Proposed School Crossing adjacent to  
49 Clyde Street, Thornbury

Traffic Assessment

25 February 2015

Source: VicRoads Traffic Engineering Manual (Figure 4.2)

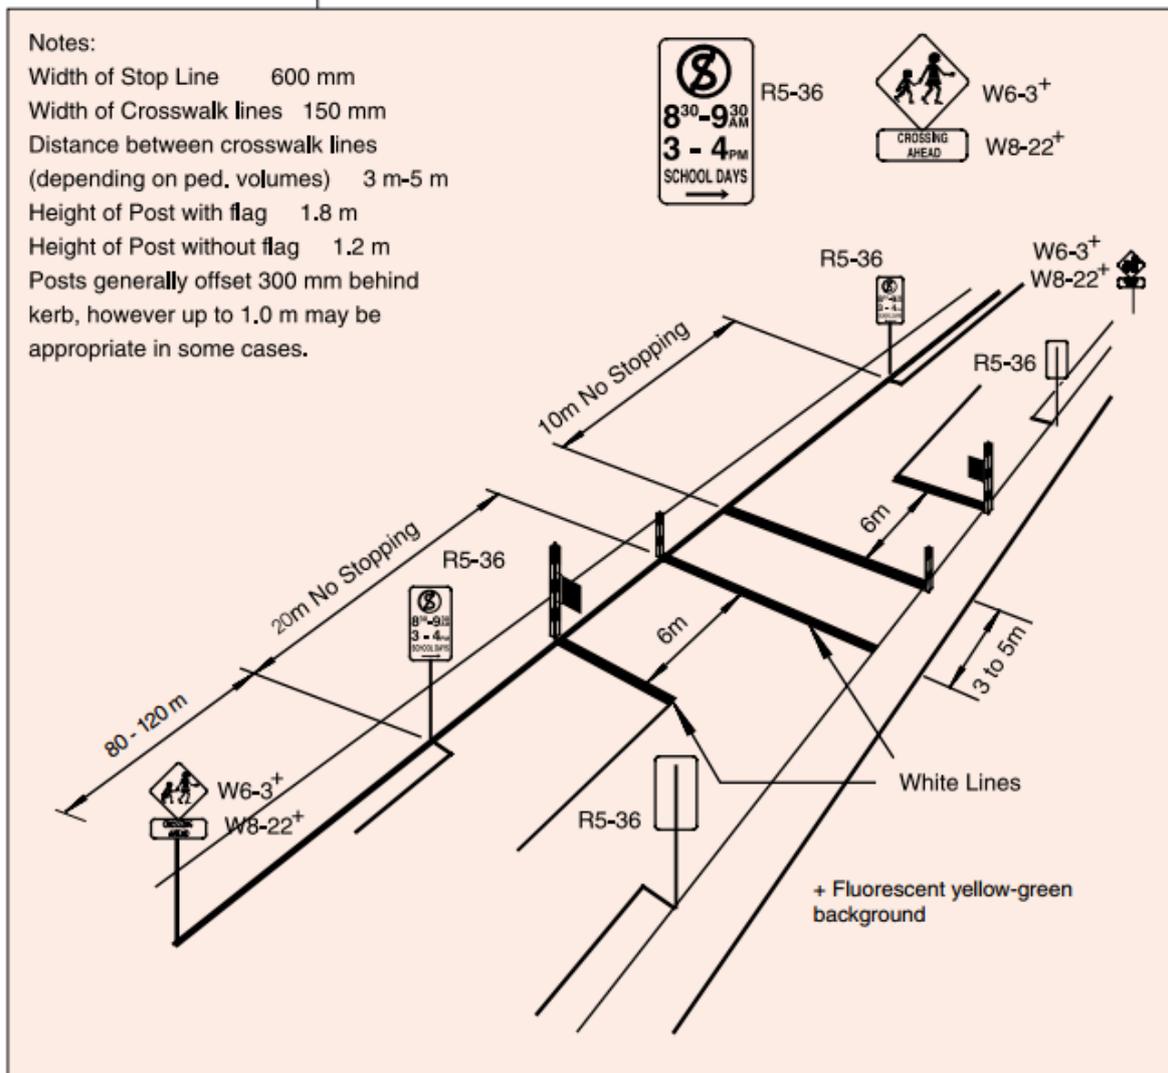
Reference however to the VicRoads' Traffic Engineering Manual, states that, in Figure 4.2 (shown in an extract on the following page), 'childrens crossing' warning signs are required to be located a minimum distance of 94 m from the crossing stop lines to achieve adequate sight lines between approaching motorists and pedestrians on the crossing facility.

The proposed 'childrens crossing' warning signs for the proposed crossing have not therefore been installed in accordance with Figure 4.2 of the VicRoads Traffic Engineering Manual. As a result, insufficient advance warning and sight lines would be provided between approaching motorists and pedestrians, potentially creating a dangerous situation.
